DEVELOPMENT DETERMINATION PANEL MEETING

WEDNESDAY 22 NOVEMBER 2023

**Agenda for a Meeting of the Development Determination Panel
to be held on Wednesday 22 November 2023
via Teleconference
Commencing at 10:00 AM**

Figure 1. Eastern side setback diagram.

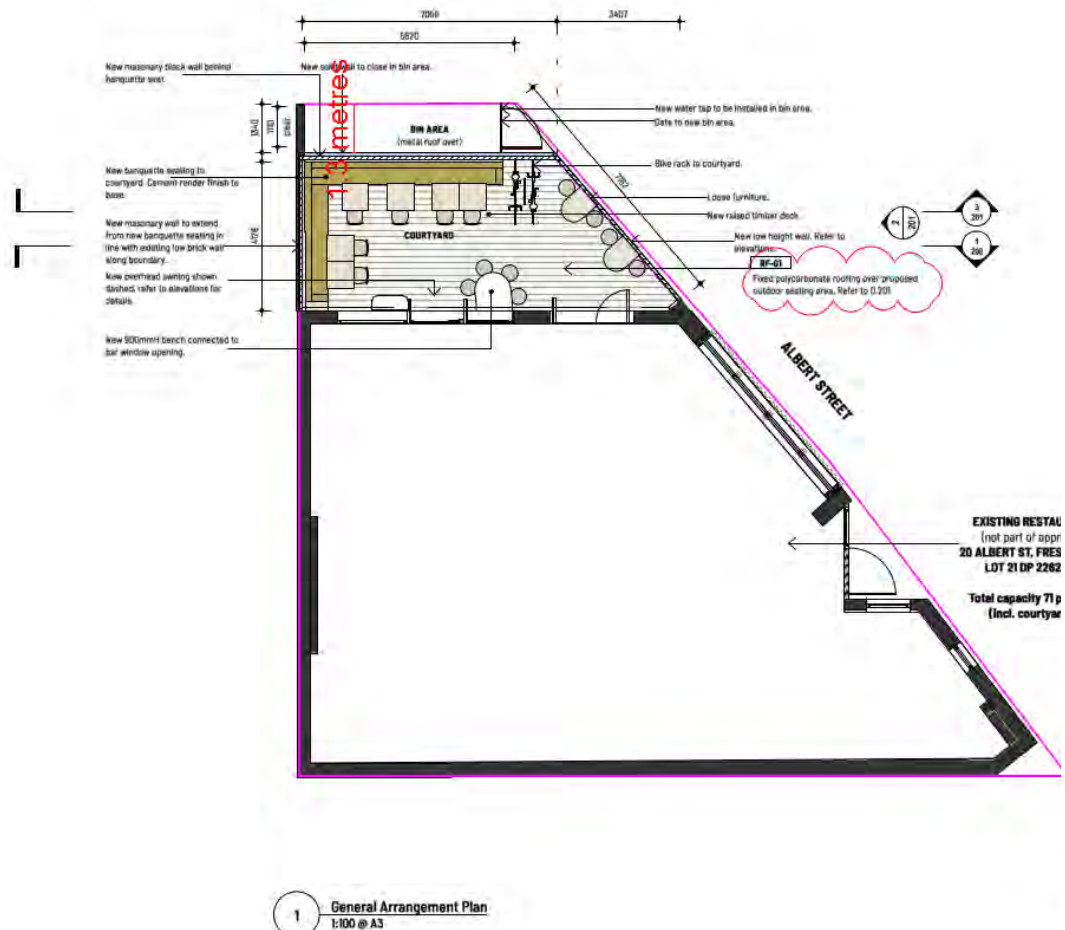
The proposed bin area is located on a nil setback to the eastern boundary and the eastern masonry wall of the new courtyard is set back 1.3 metres from the boundary, as demonstrated in Figure 1. below.

(Figure 5 and 6: Building height encroachment shown in red shading. Existing roof structure shown in red dash line).

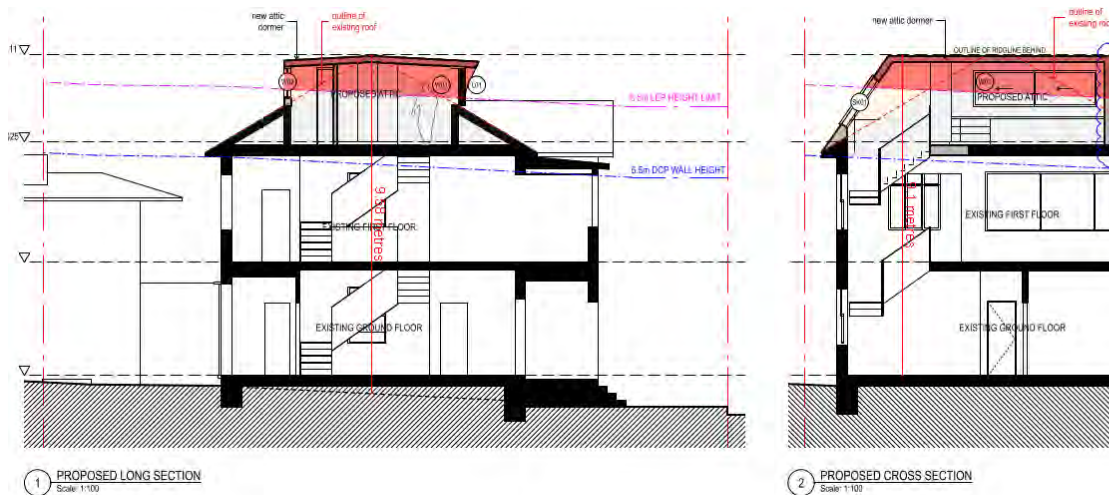
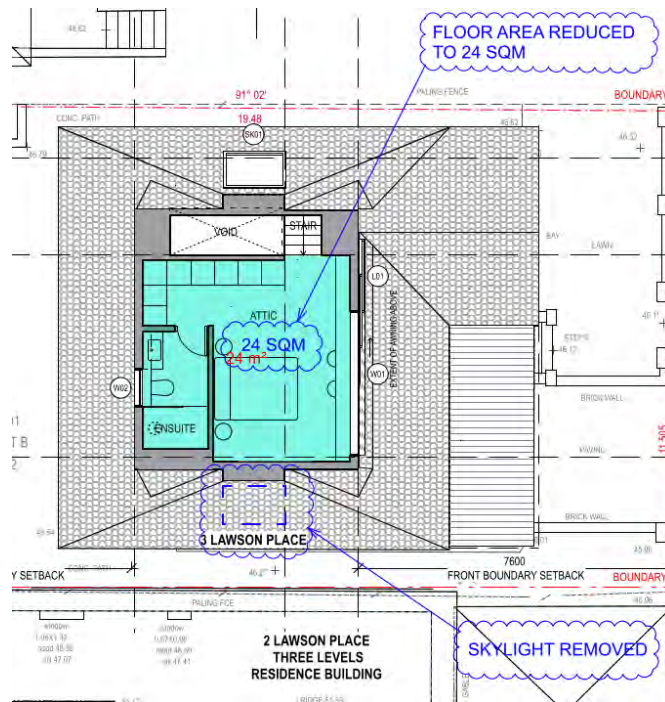
Requirement	Height: 8.5m FSR: 0.6:1 (144.18m ²)
Proposed	Height: 9.58m FSR: 0.74:1 (178.0m ²)
Percentage variation to requirement	Height: 12.7% FSR: 23.5%

(Figure 7: Additional floorspace shown in blue above - 24.0m²).

Figure 1 - Note the existing and approved new stairs for No. 33 Amiens Road located on the common side boundary shared with the subject site (No. 31A Amiens Road).

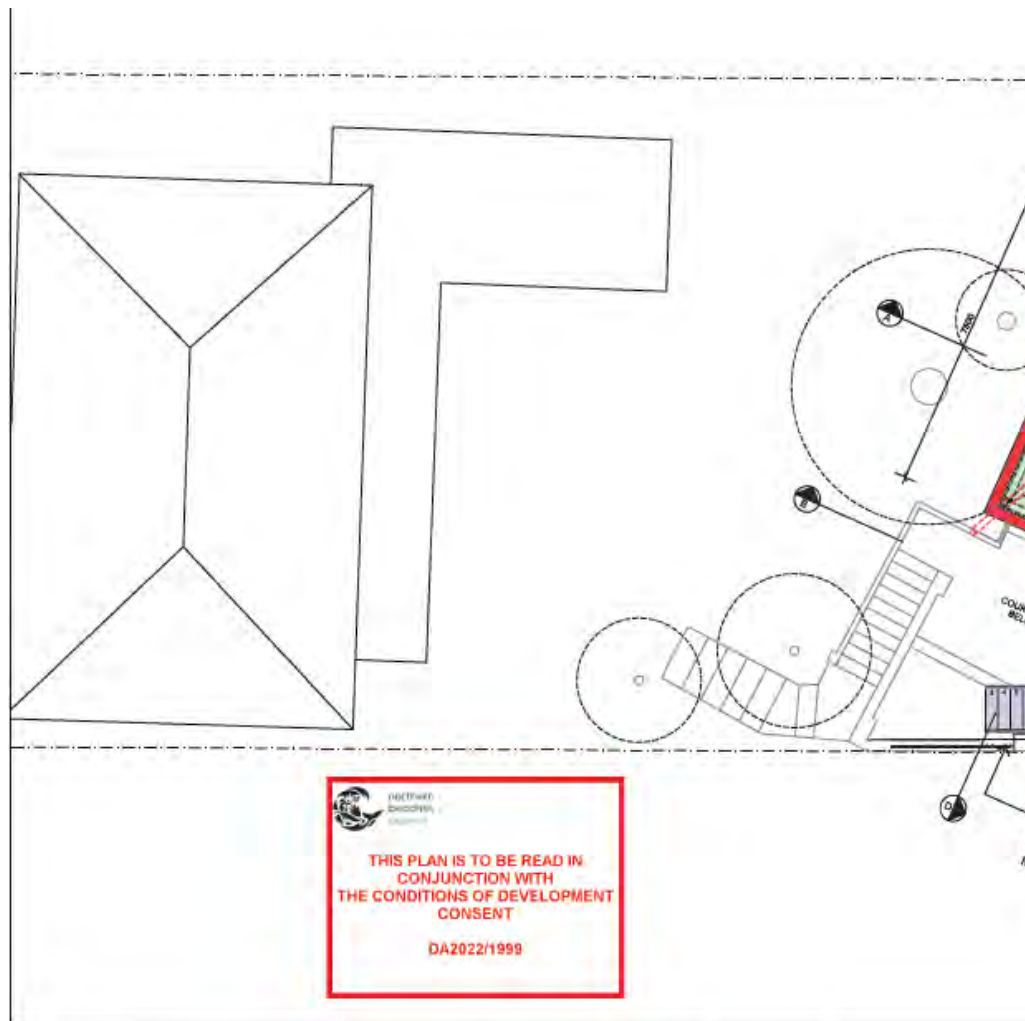
Issues was raised by the adjoining owner to the north (No. 33 Amiens Road) over the northern facing window (W8) for Bedroom 4 which faces directly to the northern side boundary. The main access stair leading from Amiens Road and the recently approved development application (DA2022/1999 - Construction of a detached carport and home office) approved 9 May 2023 at No.33 Amiens Road (see below) will create possible privacy and amenity issues for both properties:

Given the above and with the inclusion of a suitable condition in relation to privacy mitigation measures, it is considered that the potential privacy impacts have been overcome.

Figure 2 - Demonstrating windows proposed for Bedroom 4 - W7 facing west, W8 facing north and W9 facing east

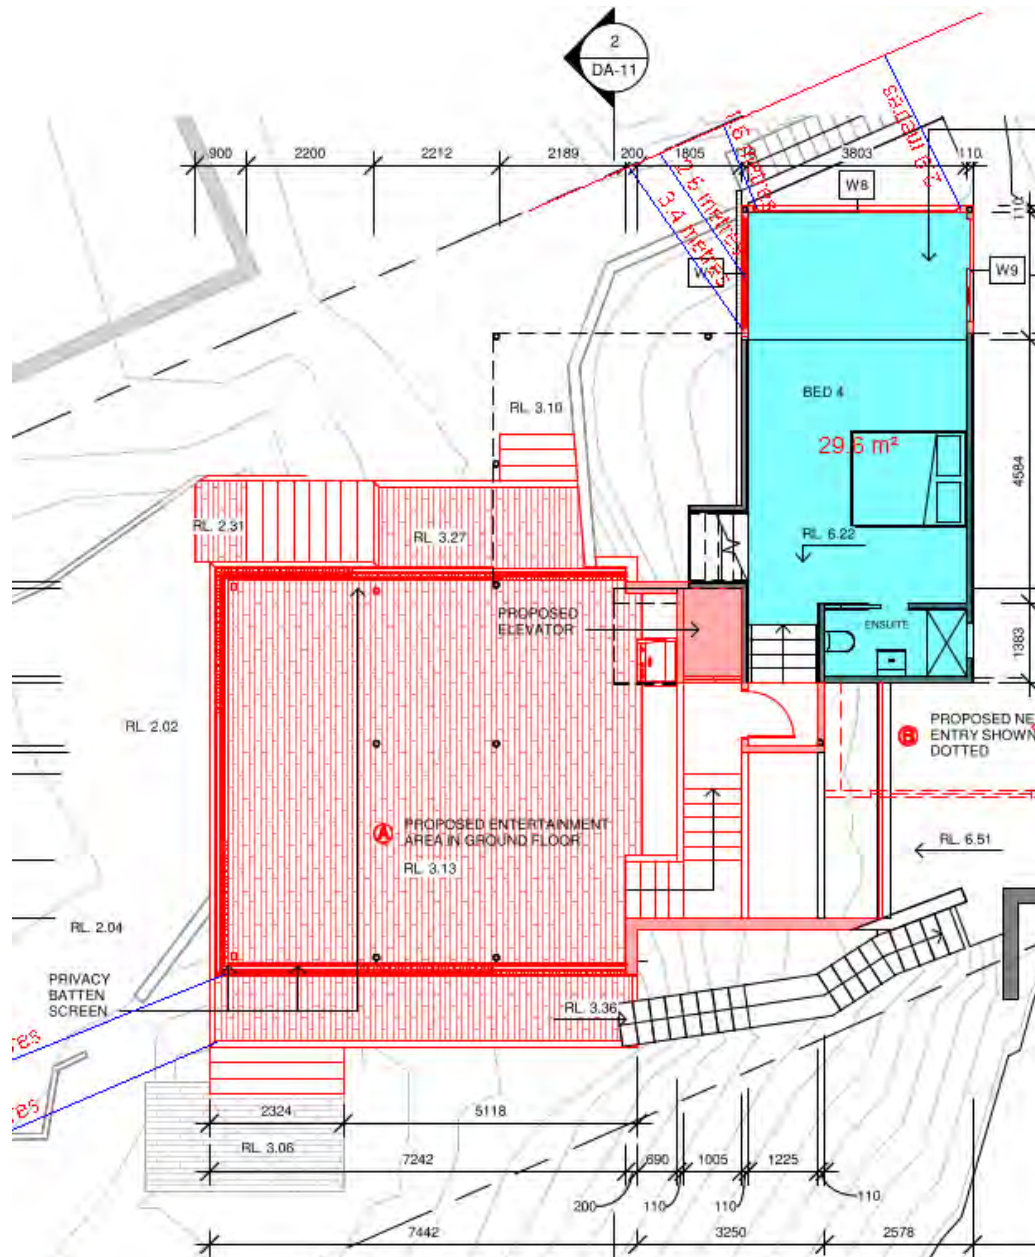
It is noted that Bedroom 4 also has windows facing to the east (W9) and west (W7) and it is considered subject to conditioning of this northern window (W8) with a high sill height of 1.5m (above the finished floor level) that reasonable privacy will be maintained for both parties. Additionally it is considered that Bedroom 4 will still receive adequate light and ventilation in accordance with the requirement for the National Construction Code (NCC).

Figure 3 - Section 1 showing maximum building height of 13.9m.

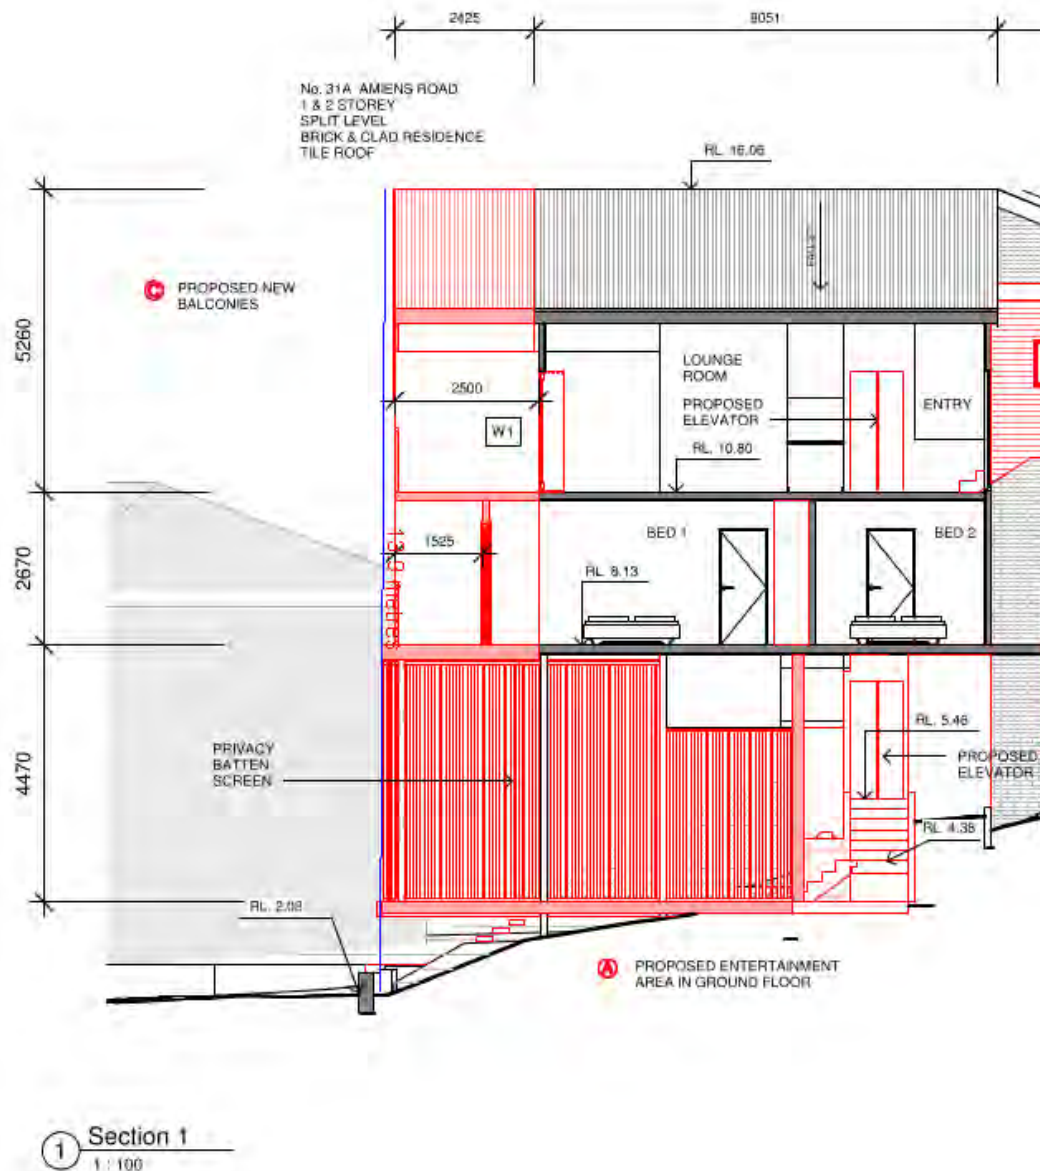
Development standard:	Height of buildings
Requirement:	8.5m
Proposed:	7m to 13.9m
Percentage variation to requirement:	63%

Figure 1: Envelope breach on the northern elevation shown in pink

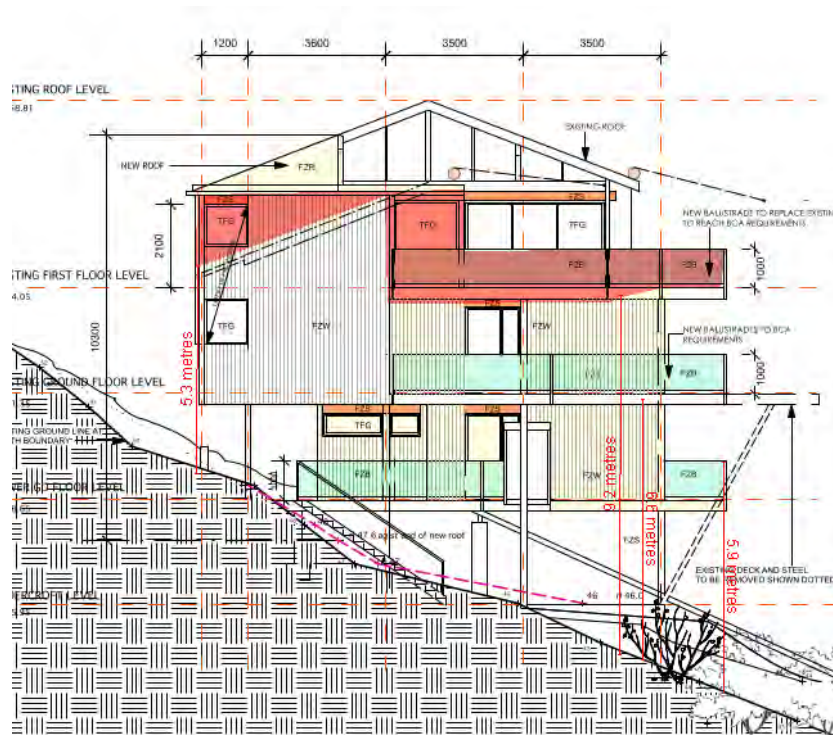
As demonstrated in figure 1 below, the new additions would predominately be below the 10m building height requirement under clause Clause 2D within PLEP 2014. The works above the 8.5m but below 10m (highlighted in pink within figure 1) are minor in nature, complement the existing built form and are primarily a result of the siting of the building and substantial slope of the land.

As demonstrated in figure 1 above, the new additions which exceed the 10m height variation consist of new retractable roof awnings and replacement balcony balustrades (highlighted in green). This would result in the development having a maximum building height of 11.4m, which represents a 34% variation from the 8.5m height requirement. These elements are considered under Clause 4.6 of PLEP below.
